MIPS R4400PC/SC Errata, Processor Revision 2.0

February 9, 1994

Figure 1a: Power-on Reset or Cold Reset- Workaround for Bug# 16

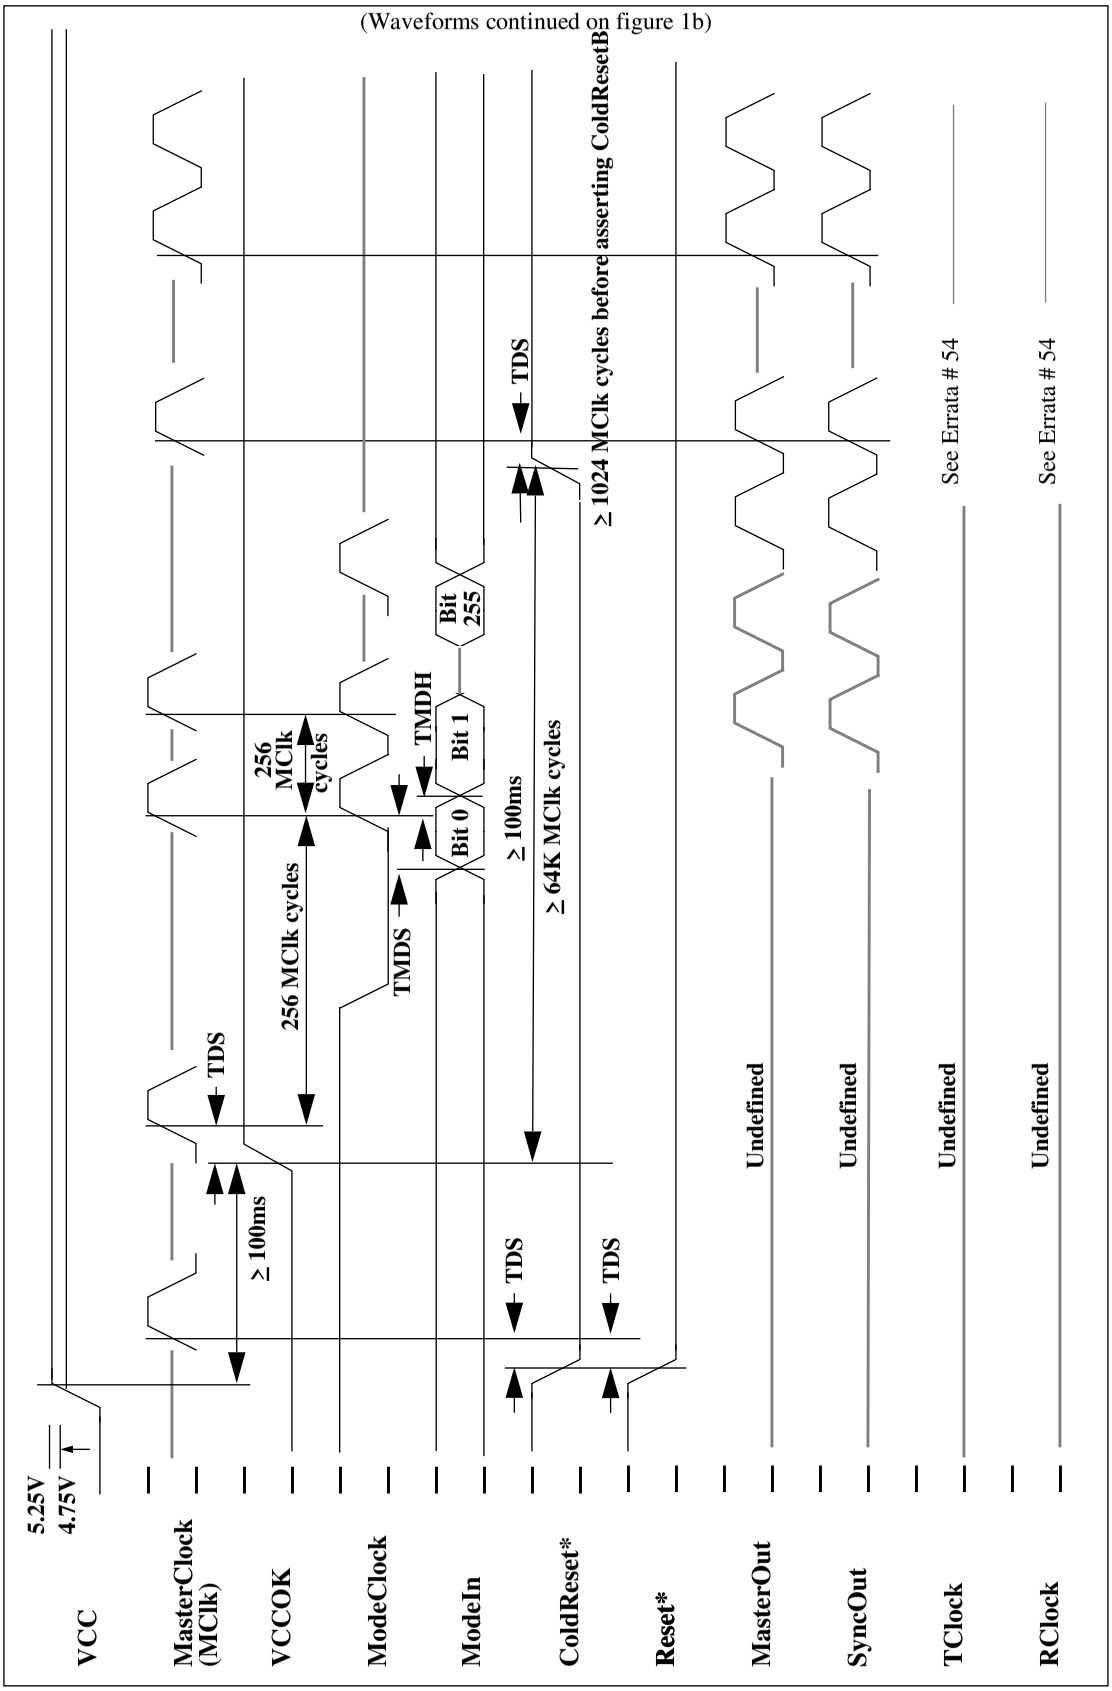
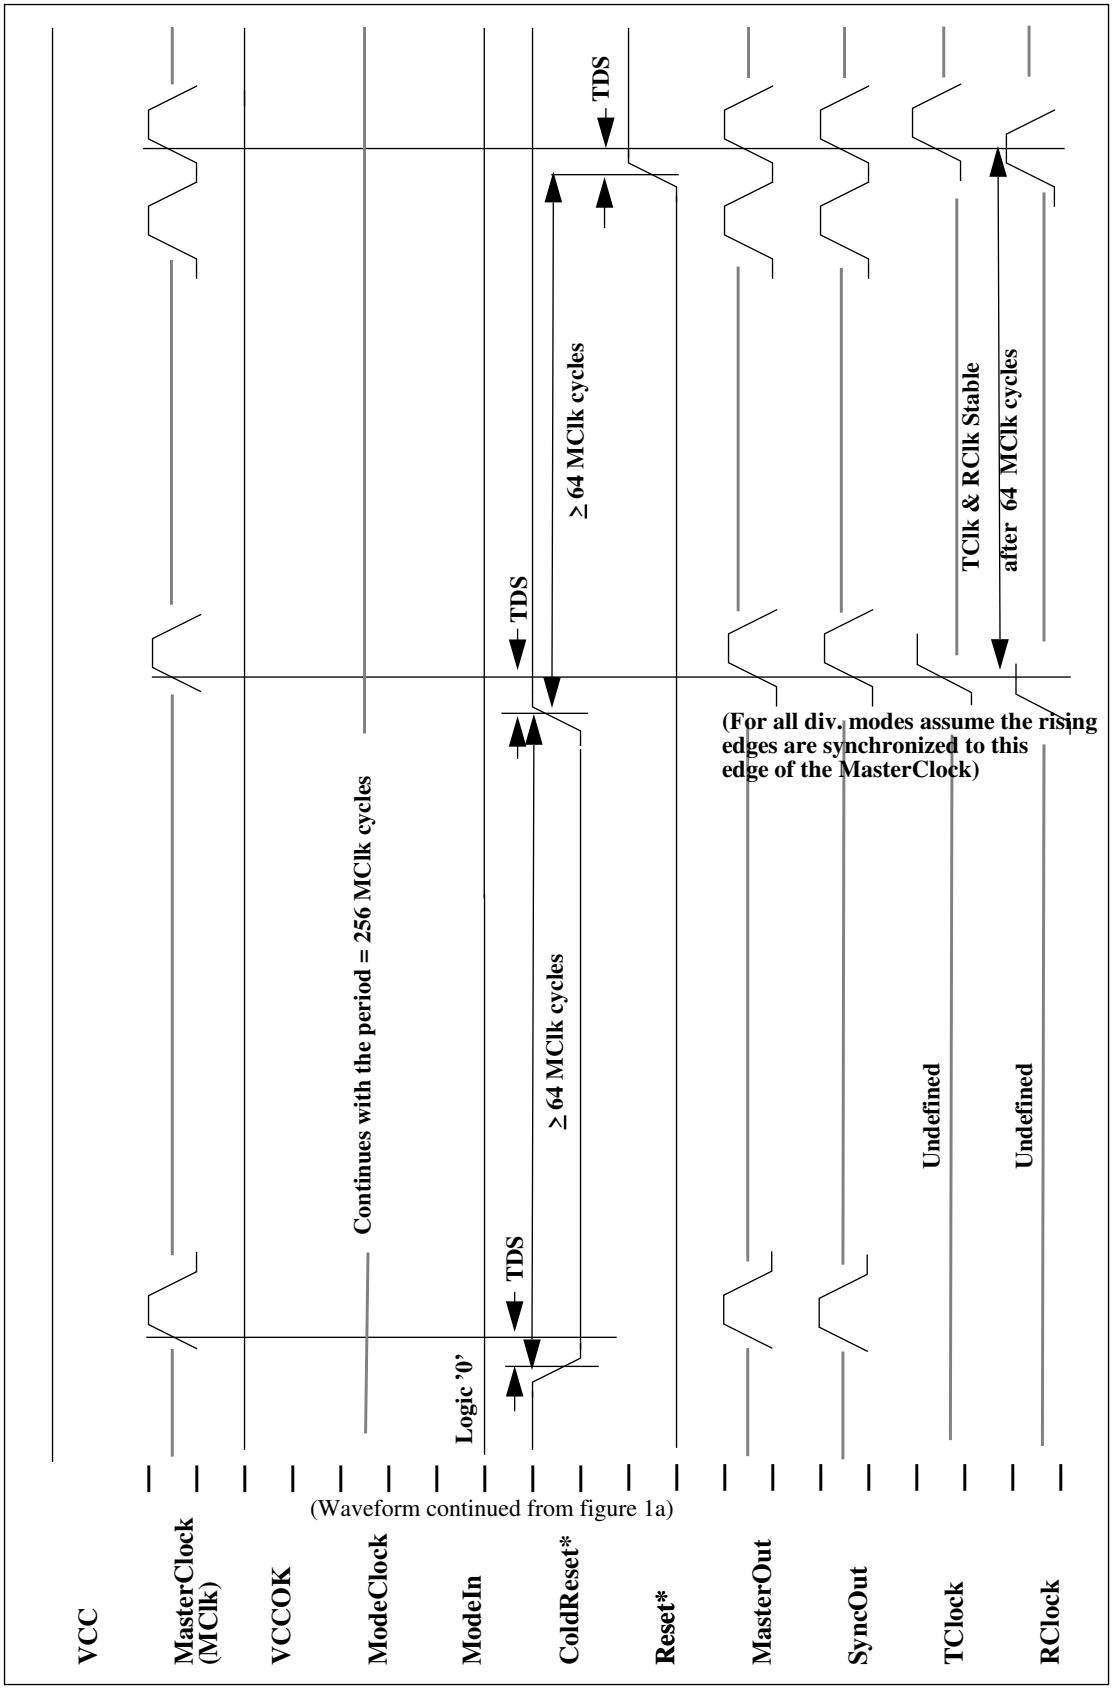
15. R4400PC, R4400SC: During the power up sequence, the period of TClk and RClk may not be as expected for at least 1024 MasterClock cycles following the de-assertion of ColdResetB. The above bug is true for all system interface divisors. Furthermore, if the system interface divisor other than 2 (i.e. 3,4,6 & 8) is used, TClk and RClk's rising edge may not align to the rising edge of the MasterClock, as specified.

Thus, for system with interface divisor set to two, the only violation will be that the TClk and RClk's period might not be valid within 64 MasterClock after the ColdResetB is de-asserted.

Workaround: Assert a second ColdResetB after at least 1024 MasterClock cycles from the de-assertion of the first ColdResetB. ResetB should remain asserted until at least 64 MasterClock cycles following the de-assertion of the second ColdResetB. TClk and RClk will then be valid 64 MasterClock cycles after the de-assertion of the second ColdResetB and their edge alignment with respect to MasterClock will be as specified. Figure 1a & 1b show the waveforms in more detail. Note that the waveforms in Figure 1b are continuation of the those in figure 1a.
